350 CEMENT CONCRETE PAVEMENT SPECIFICATION
COMMENTS FROM INTERNAL/INDUSTRY REVIEW

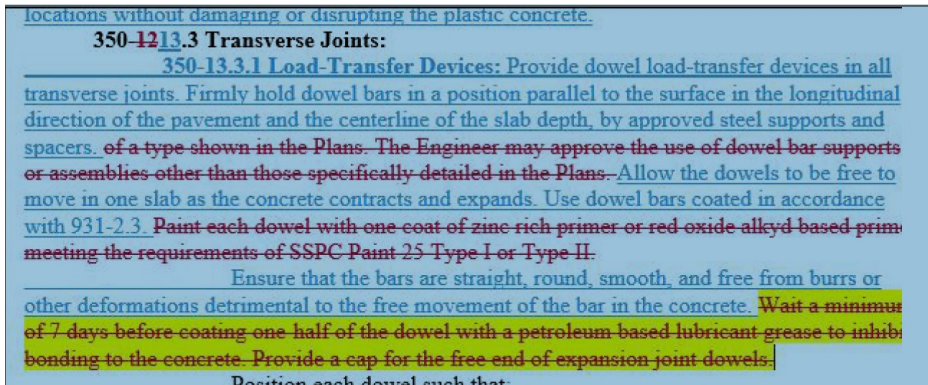
In 350-13.3.1 Load Transfer Devices, they are proposing to eliminate the Spec language that requires greasing (lubricating) half of each dowel bar. I recommend we allow that requirement to remain. My reasoning is that it is important for the slabs to be able to expand and contract independent of one another and greasing the dowel bars helps ensure this occurs. There are other requirements regarding bar alignment that also helps, but greasing half the bar ensures only one half of the bar could possibly be constrained in a slab while the other end is free to move. Please see the screenshot below, I believe the Spec language they are proposing to delete (that I have highlighted in yellow) should not be deleted from the Specifications, this language should remain.
